SUBJECT: 1. Environmental Determination;

Rezone from A. Agricultural to R-1-A, Townhouse 2.

Tentative Map (P82-090)

SUBJECT: Northwind Estates

SPLIT GARAGE FLOOR PLAN (NEW FLOOR PLAN)

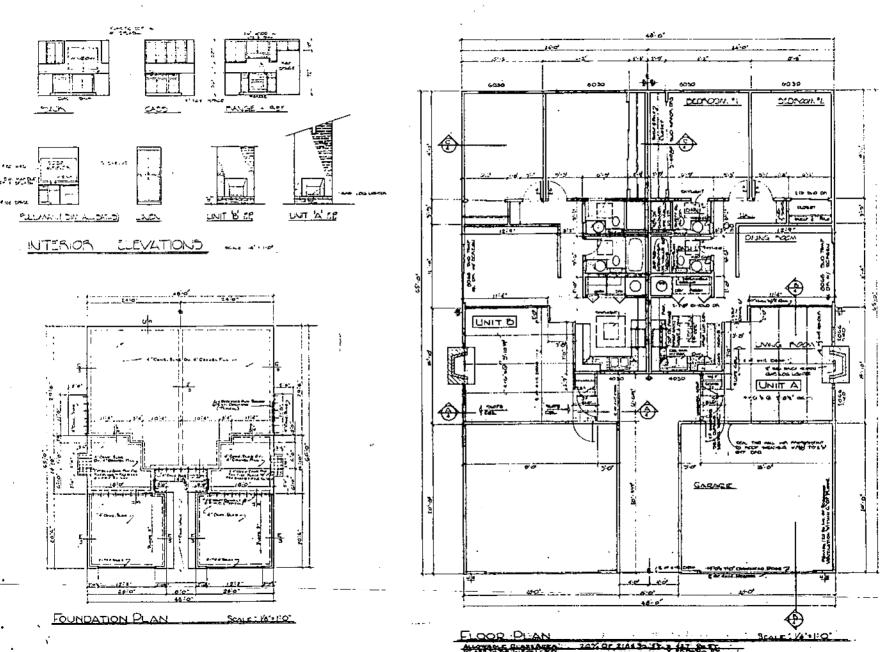
- 1. Staff believes the 'modifications' made to the project constitute little more than token attempts to address concerns expressed by both the staff and the Planning Commission. There are now 18 units with split garages. Elevations for the modified unit 2081 were not submitted and staff has not included that as a 'split' elevation. No garages are oriented away from the street, however some driveways have been modified for a curved affect with a small planter area. Nothing has been done to address varied width, logically corresponding indoor/outdoor living area, a variety of floor plans and elevations, solar access, and visual interest of streetscapes.
- Staff believes that a minimal effort has been made to provide a visually pleasing streetscape with interest and variety.

- f. All units designated #2081 shall be as originally submitted with garages adjacent to one another.
- g. There shall be additional structures of the unit 2184 design distributed on long street frontages. These shall not replace any unit 'H' design.
- h. Units 'A' thru 'H' with living areas in the rear of the structure shall have at least a 15-foot rear yard setback.
- i. Units on lots 292, 293 and 296 shall be located 5-feet from the property line.
- j. Outside building materials of on front elevations shall be indicated for each unit.
- k. There shall be no deviation of unit patterning without prior Planning Department approval.
- 2. The revised schematic plan shall be submitted for review and approval of the Planning Director prior to Tentative Map approval.
- Prior to issuance of building permits, all plans shall be reviewed for compliance with the approved schematic plan.
